VICTORIAN CIVIL AND ADMINISTRATIVE TRIBUNAL

VCAT REFERENCE NO. P673/2024 PERMIT APPLICATION NO. TPA/55514

APPLICANT	Tania Naomi Wisel
RESPONSIBLE AUTHORITY	Monash City Council
	Paul Economedes
SUBJECT LAND	16 Clapham Road HUGHESDALE VIC 3166
HEARING TYPE	Hearing
DATE OF HEARING	20 February 2025
DATE OF ORDER	24 February 2025
CITATION	Wisel v Monash CC [2025] VCAT 168

Description of proposal	Construction of three, double storey dwellings.
Nature of proceeding	Application under section 82 of the <i>Planning and</i> <i>Environment Act 1987</i> (Vic) – to review the decision to grant a permit.
Planning scheme	Monash Planning Scheme
Zone and overlays	General Residential Zone – Schedule 2 ('GRZ2')
Permit requirements	Clause 32.08-7 construct two or more dwellings on a lot in GRZ2.
Key relevant scheme policies and provisions	Clauses 11, 15.01, 32.08, 55, 65 and 71.02-3.
Land description	The site has a 20.12 metre frontage to the east side of Clapham Road and a depth of 45.7 metres to create an area of 919.8 square metres. The land is vacant. To the north are three, single storey dwellings on a similar sized lot. To the south is a single storey dwelling. To the rear is a modern single s

Figure 1 - section of 3pm shadow diagram in application plans showing alignment of the proposed rear dwelling to the rear of 17 Paddington Road.

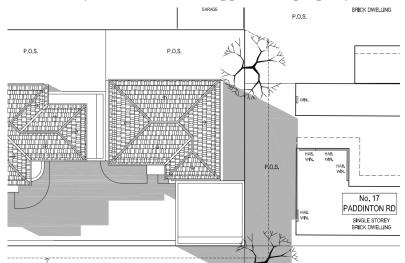
11 The applicant submits that the rear building interface with a two metre wide setback and garage to rear boundary is too close and imposing on their property, having regard to the character sought for the GRZ2 area. This is noting that while the review site is 20 metres wide, the building extends across all of the interface to the applicant's property, that is only 15 metres wide. As depicted in figure 1 below, the northern five metres, that remains open does not directly interface review applicant's property.

- 22 The applicant submits that the two metre wide space between the rear of dwelling 3 and the rear boundary is insufficient to provide canopy planting that can soften the building when viewed from the rear yard of 17 Paddington Road.

- 24 The applicant submits that height and form of dwelling 3 and its garage will unreasonably overshadow her SPOS located to the rear of 17 Paddington Road. This adjoining SPOS forms part of a larger SPOS that forms a mostly enclosed, internal courtyard of the dwelling at 17 Paddington Street. I am satisfied that when assessing the SPOS area of this adjoining site, as a whole, standard B21 at clause 55.04-5 is met. The scheme directs that if the standard is met then the objective is also met.

- 21 I will direct that the garage wall to the boundary be reduced in height to no more than 3.2 metres from natural ground level at the rear, eastern boundary to avoid any further impost on adjoining properties from visual bulk and on backyard character.

- (a) Survey levels showing natural ground level (NGL) across the site.
 - (b) The walls on boundary to the garage to dwelling 3 reduced in height to be no greater than 3.2 metres high from natural ground level at the rear, eastern boundary.
